Planning & Zoning Board

Thursday, July 6, 2023

RE: Sheetz Taylor and Main, 8555 East Main Street – Sign Variances.

Statement in Support
Modified May 11, 2023

WEST BOUND VIEW AT US-40 APPROX 200FT TO TAYLOR RD

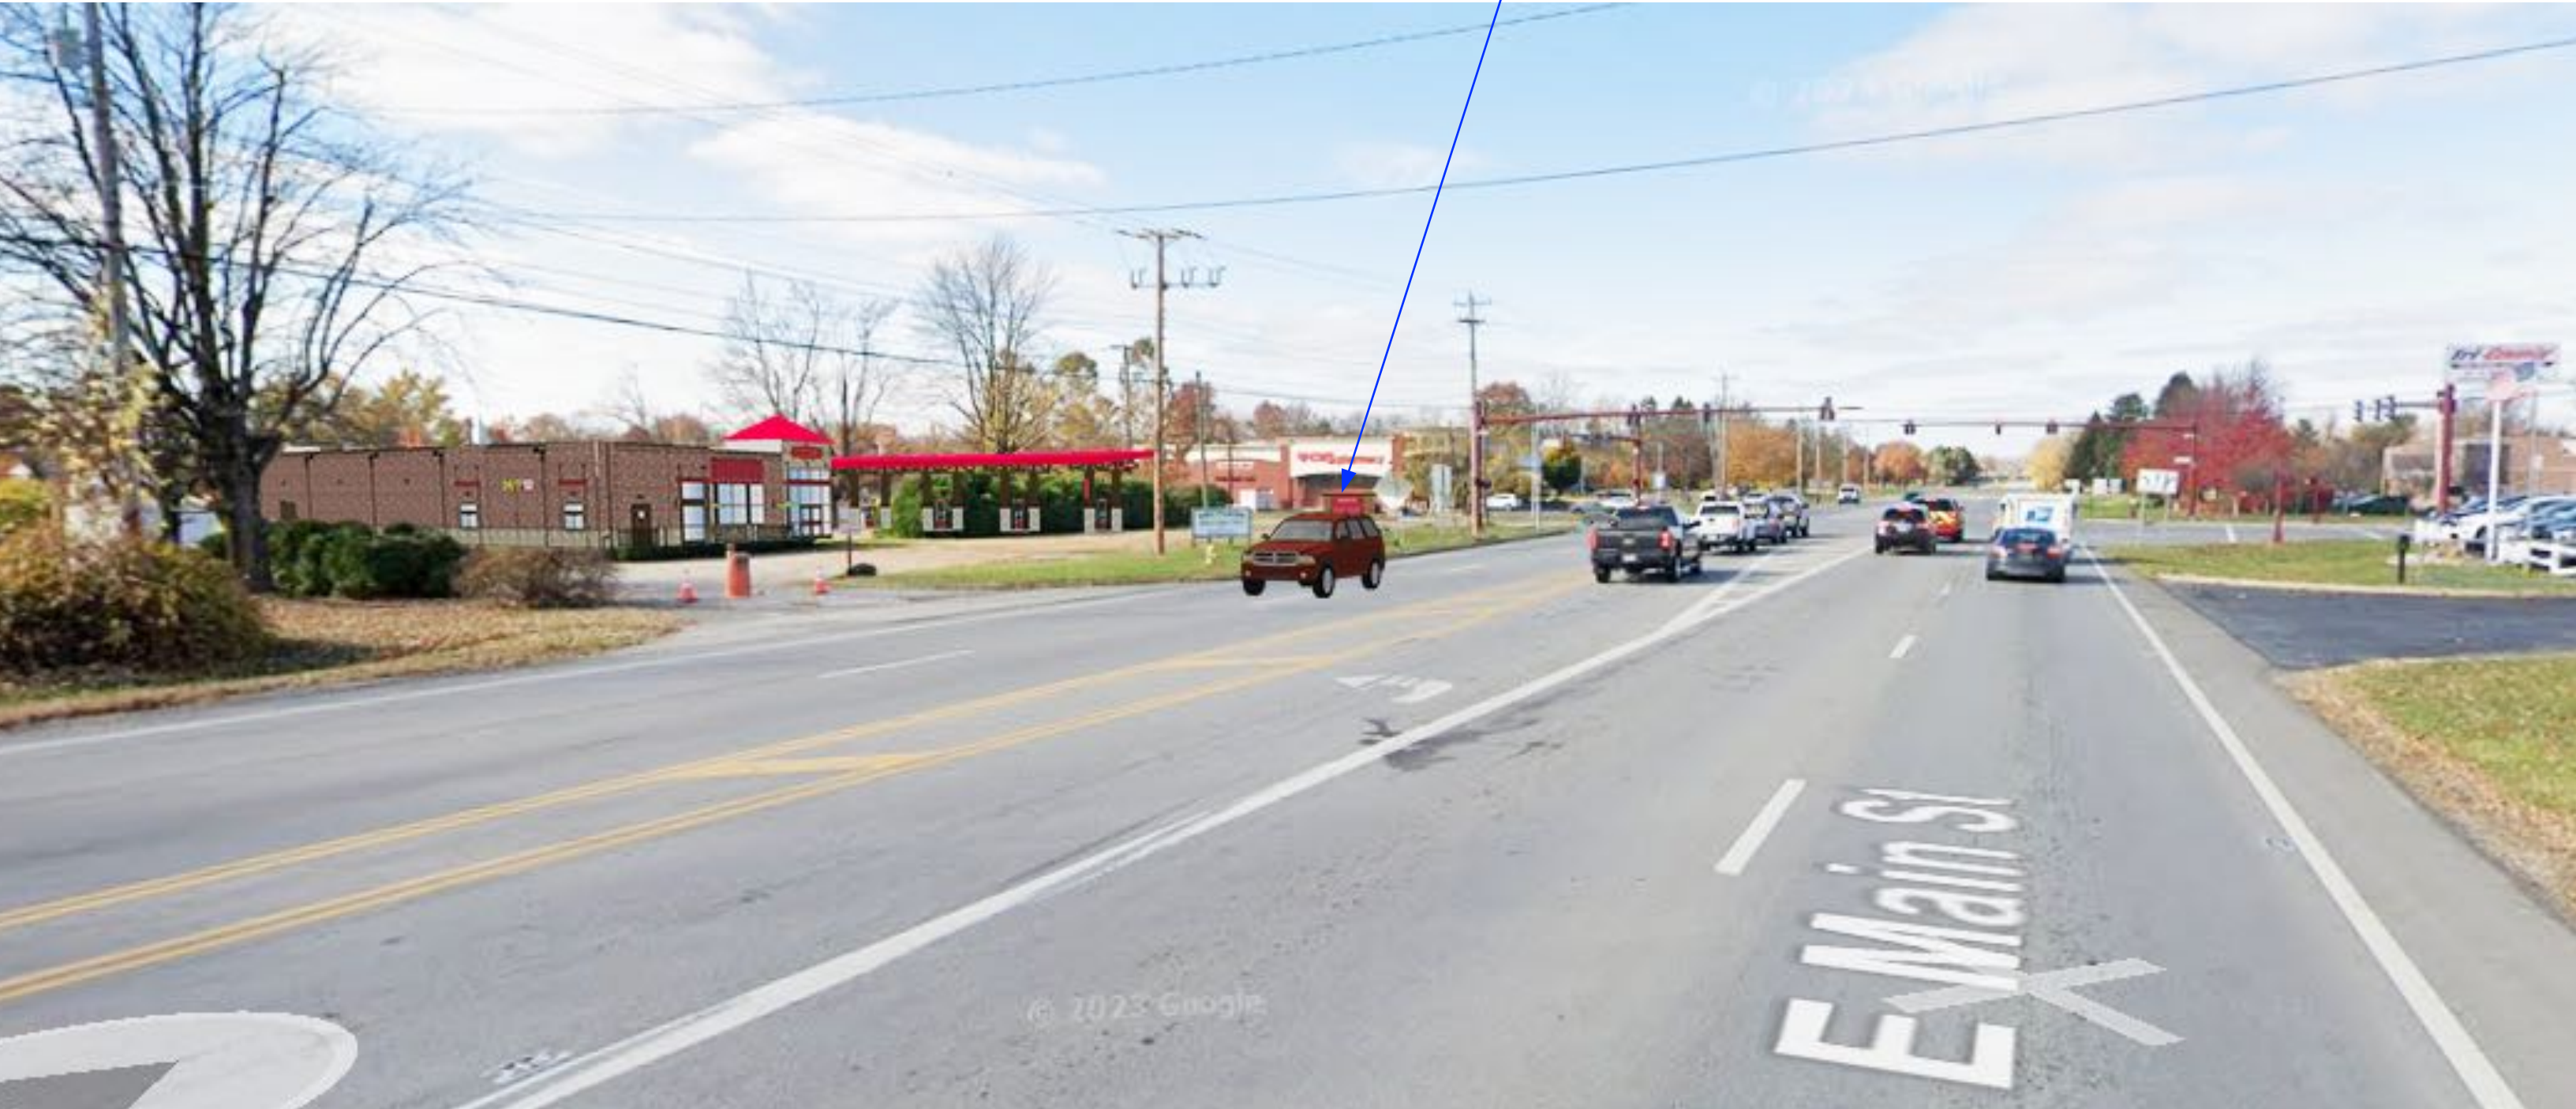
Customers driving west will approach the site at 35mph. The proposed monument sign is 8 ft. It lifts the price signs up to 36.75in. It is reasonable for a gas station to have its gas prices to be visible to passing drivers, and Sheetz has revised its request from 9ft to 8ft. This is the minimal height required. If the sign is limited to 6 ft, the gas prices will only be 10.75in from grade, and 6.75 in from grass height. Requiring drivers to view prices at about 6in from the height of the grass is unreasonable and creates a hardship.

A driver's minimum reading-to-reaction time is 6 to 8 seconds. In 6 to 8 seconds, the driver will need to decide to purchase gas at the exhibited price and react to turn into the site. A driver traveling on East Broad will be traveling 35mph. That driver will have 308ft to read-and-react.

The Manual on Uniform Traffic Control Devices recommends 1 inch of text for every 30ft of legibility distance. The existing price digits are 14 inches in height so are legible at 420ft. The price digits are designed to be the minimum necessary to promote driver safety on adjacent roadways.

However, if the digits are approximately 6 inches from the top of the grass, readability will vary depending on traffic hindering a consumers' ability to react safely. The more traffic is on the road, the less likely the driver will see the price and respond safely. East Main Street is a well-traveled. In 2021, MORPC counted 13419 travelers on the east side of the Taylor & Main Street intersection.
